SERVICE BULLETIN	
Service Bulletin #	AASB-1-1-2011
Superseded Bulletin #	n/a
Issue Date	1-31-2011
Effective Date	1-31-2011
Limitations for Completion	Next scheduled inspection
Make & Model Affected	Lightning LS-1 SLSA &ELSA
	SN78 thru 107
Page 1 of 3

1. Applicability: Lightning LS-1 SLSA or ELSA aircraft in the effected serial range of SN87 thru SN107.

Figure 2: deformation of lower socket plate V1

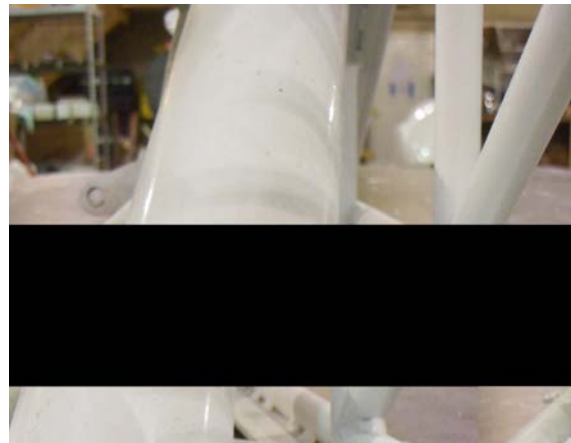
Refer to figure 2: The lower socket plate must be inspected as well. This plate may have up to 1/16” flex upwards and be with in serviceable tolerance. However should more than that be found upon inspection the box should be replaced. Check by using a short straight edge set between the spar box tubes across the plate. Measure the deflection if any.
